From: BLEAKLEY Ashley
Sent: Thursday, 1 February 2018 9:20 AM
To: JOHNSTON Luke; CLAUS Sonia
Cc: LARSEN Daniel; DAVIDSON Kylie; ROSENBERG Megan; BATTS Kathy
Subject: Limited review of Groundwater model - East End
Attachments: Review of Pacific Environment report Januray 2018 AB DL.docx

We have been requested by the Cairns Office (ex EHP) to review a groundwater model report to determine appropriate groundwater level triggers to be applied in an EA for East End Mine. Specially, the Officer has requested "a review of the groundwater model that has been developed for the project site to determine groundwater level triggers and also to ensure the proposed groundwater monitoring bores are within the same hydrogeographical zones."

Review of groundwater modelling report**East End 11 January 2018****Pacific Environment****Introduction**

Model Calibration and Validation 5.3

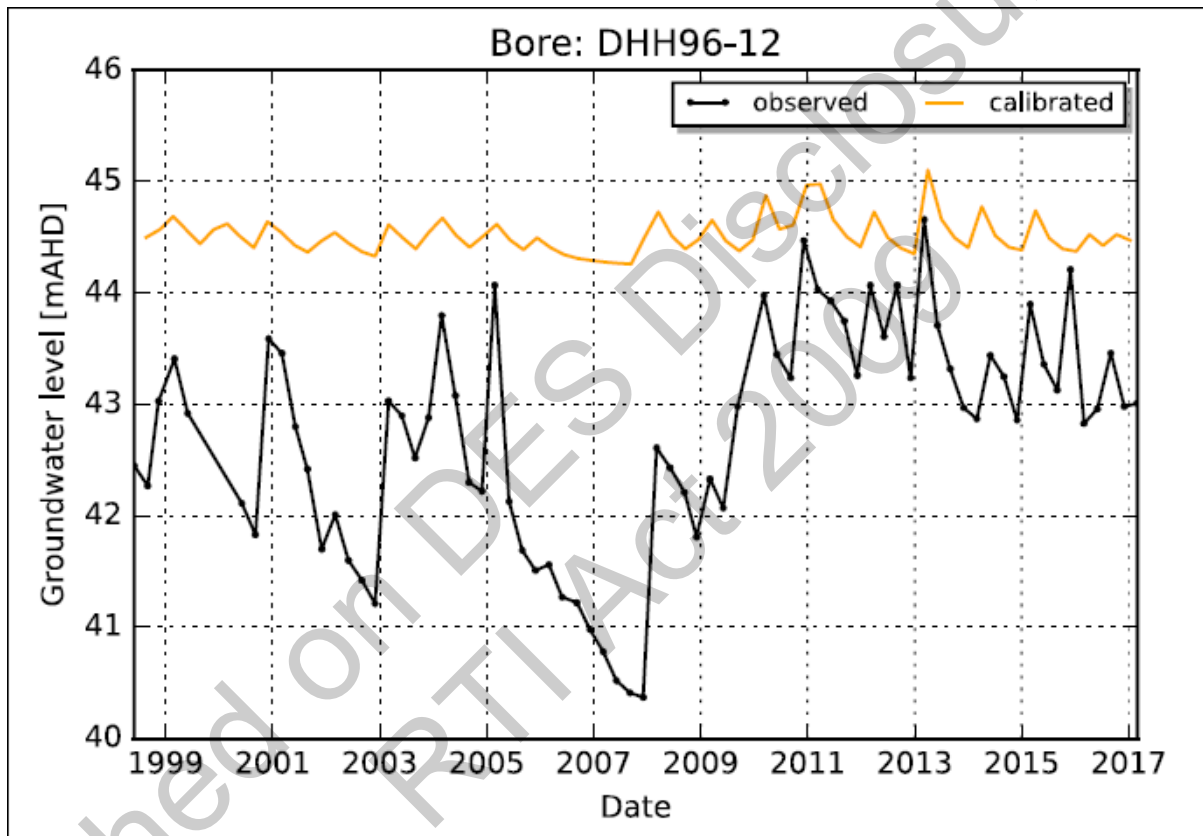
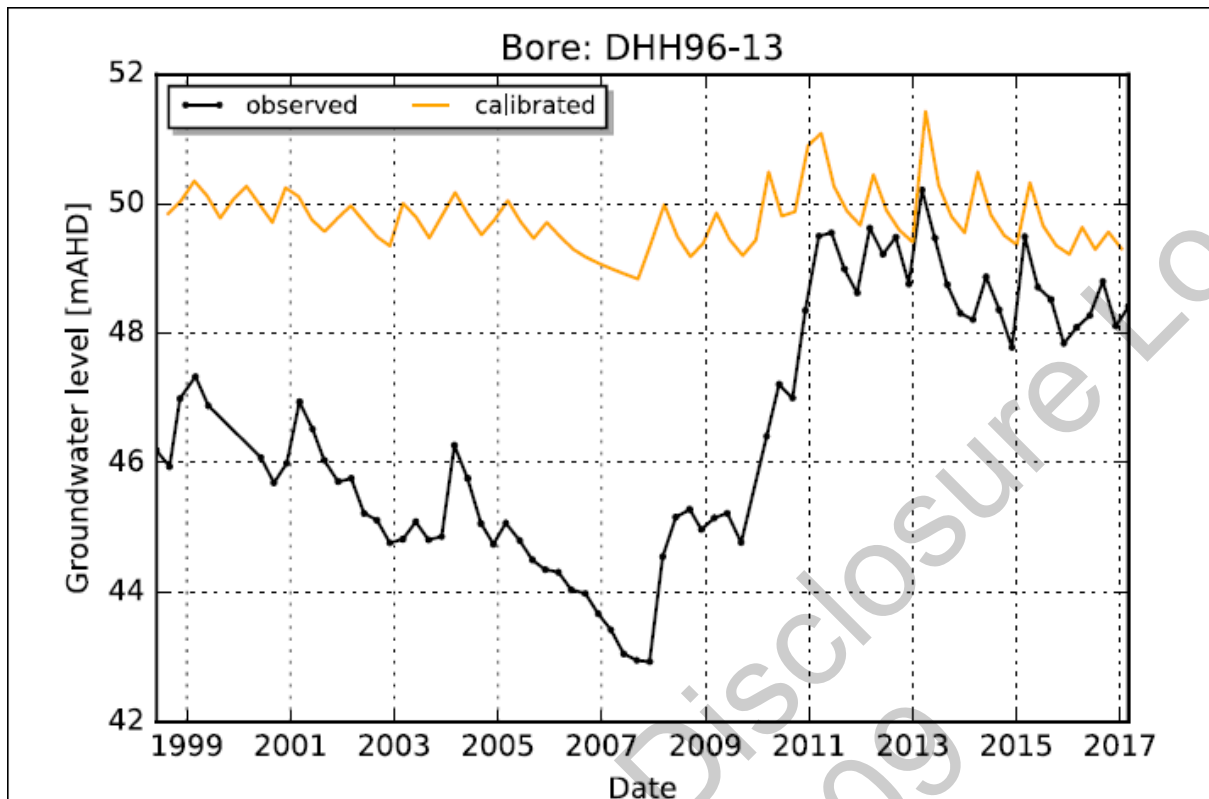
It appears from section 5.3 that a steady state calibration was carried out to determine K in the 15 zones and the 11 creek leakage factors. Figure 24 shows the locations of the 15 K zones and table 15 discusses the creek sections. A map showing the creek sections would assist. The draft report currently does not label any streams on any of the maps which makes it difficult to follow the discussion.

It is then assumed that these parameters were accepted and used to run the transient model from 1980 to 2017 as a validation. Hence K appears not to have been calibrated in transient mode. It appears that during this process a storage coefficient of 1% was adopted by way of some manual best fit process.

The description of this transient process is very limited.

In most calibration bores the elevation of the calibrated water level in the validation period looks reasonably good in comparison to the observed water levels.

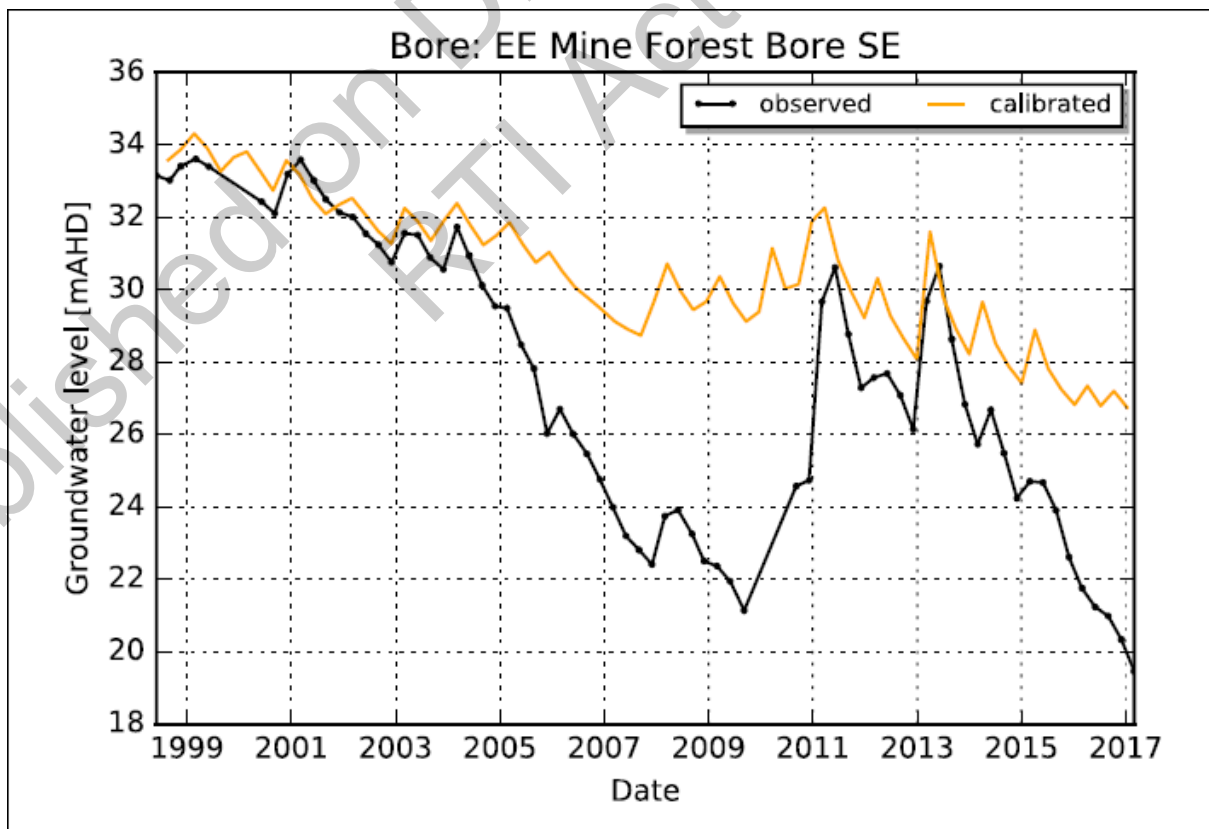
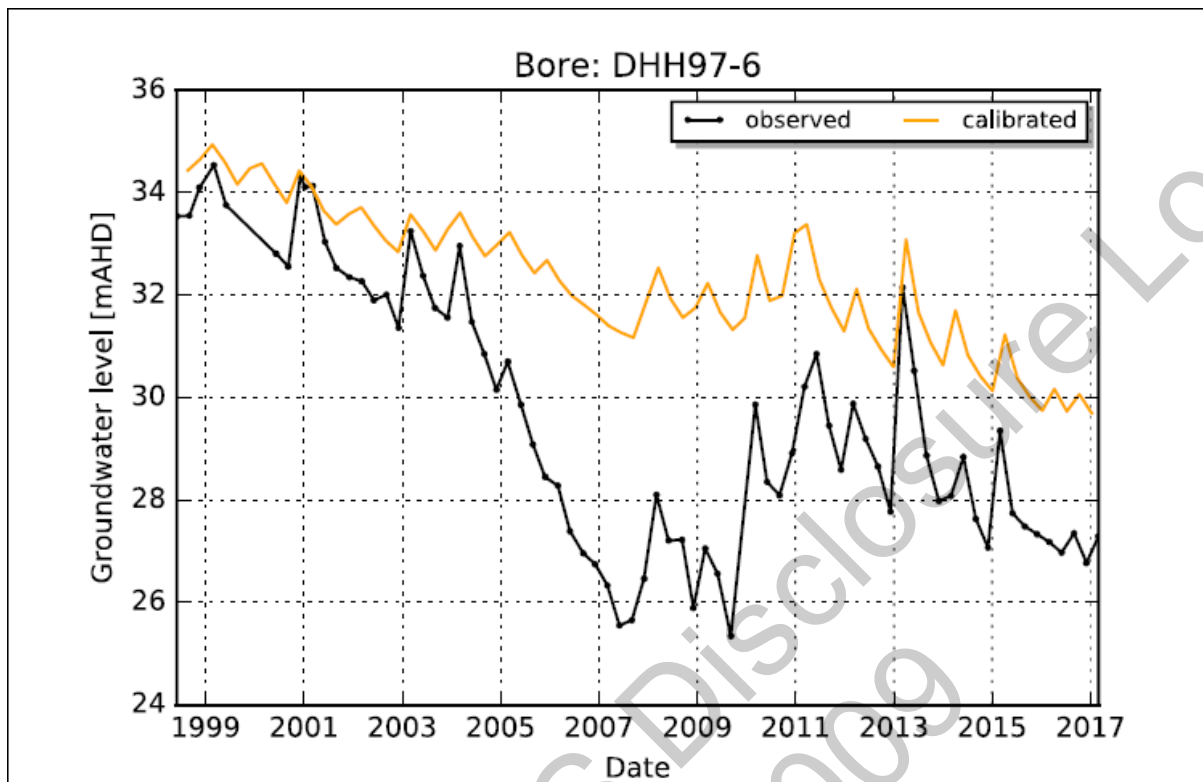
West of the pit the elevation of the calibrated water levels look ok but reproduction of drawdown and recharge response is poor. Typically the model is not predicting enough drawdown in the calibration (validation) period in this area. DHH96-12 and DHH96-13 are examples.

Then to the east, EE Mine Forest Bore SE and to the south east, bore DHH97-6, similar issues are noted.

Hence this can be an issue in some areas where the model is consistently under predicting drawdown given that prediction of drawdown is a key aim of the model.
